UNITED STATES PATENT AND TRADEMARK OFFICE

APPLICATION NO.	FILING DATE	FIRST NAMED INVENTOR	ATTORNEY DOCKET NO.	CONFIRMATION NO.
10/615,133	07/08/2003	Mary Morabito O'Neill	02W234	8119

Office Action Summary

DETAILED ACTION

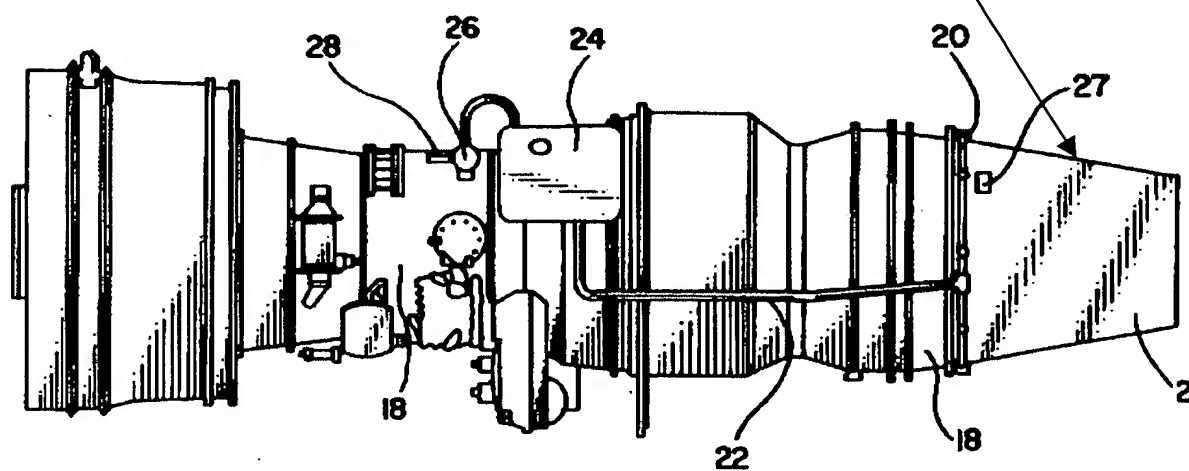
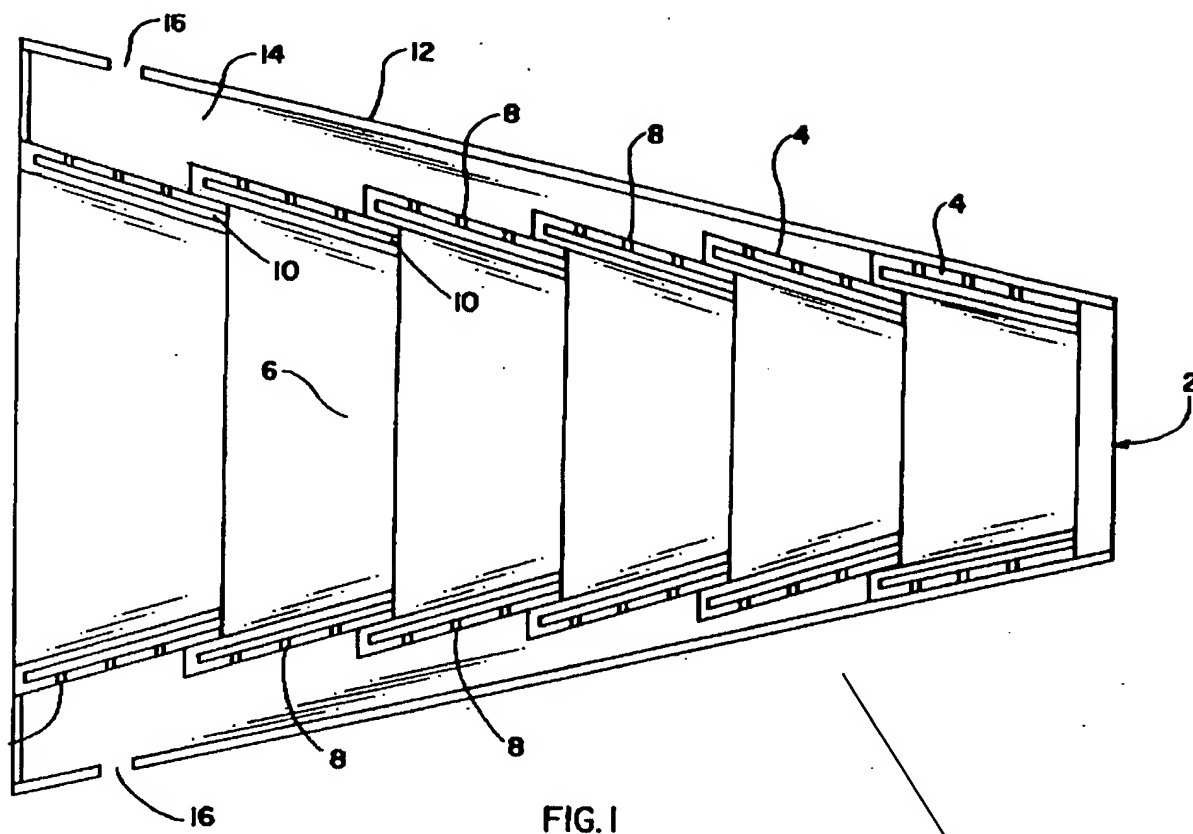
U.S.C. 102(b) as being anticipated by US 5269132 issued to Loucks. Loucks discloses a method for obscuring a transport aircraft from a serious threat of surface-to-air and air-to-air infrared guided missiles. A jet aircraft engine having a tailpipe is shown in Fig. 5. The tailpipe includes a nacelle covering forming a liquid cooling chamber with a plurality of cooling panels 4 as shown in Fig. 1. The cooling chamber is supplied with a coolant mixed with water (col 3, ll. 4-9) contained in a reservoir 24. The coolant is ejected from the reservoir 24 via coolant line 22 to the coolant chamber and into a cavity formed within the cooling panels 4. The coolant filled panels form a vaporous boundary layer between an external viewing location and the heat source, which comprises engine exhaust flowing from the aircraft. The device can be used on auxiliary engines as well as main engines. The aircraft is not disclosed as having a flare or early warning system. The coolant does not mix with the gas discharge.

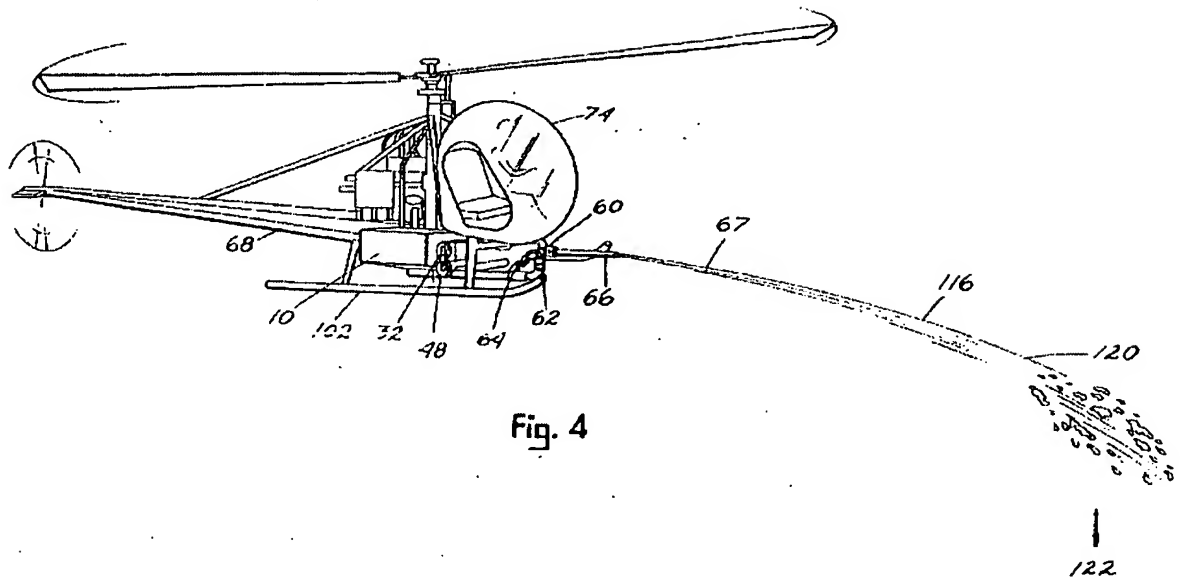
9. Claims 1, 2, 4, 6, 11, 14, 16, 22, 23, 24 and 26 are rejected under 35 USC 102(b) in view of US 4979571 issued to MacDonald. MacDonald discloses a method for obscuring an aircraft from infrared detection. Specifically, MacDonald discloses a foam producing apparatus for fighting fires comprising a helicopter as shown in Fig. 4 for transporting a pilot and fire retardant. A viewer at reference number 122 with infrared capabilities can see the heat given off by the engines of the helicopter. A mixture of CO₂ and water is used to put out fires (col. 6, ll. 41-66) at 122. A viewer at viewing location 122 would have its view of the engine heat (or exhaust plume) obscured by the flow of fire retardant. The obscurant is generated on the aircraft as shown at col. 6, ll. 41-66+. The method is capable of obscuring an auxiliary unit of the helicopter as well as the main engines. There is no disclosure of flares or infrared systems on the helicopter. The retardant is ejected from the front of the helicopter.
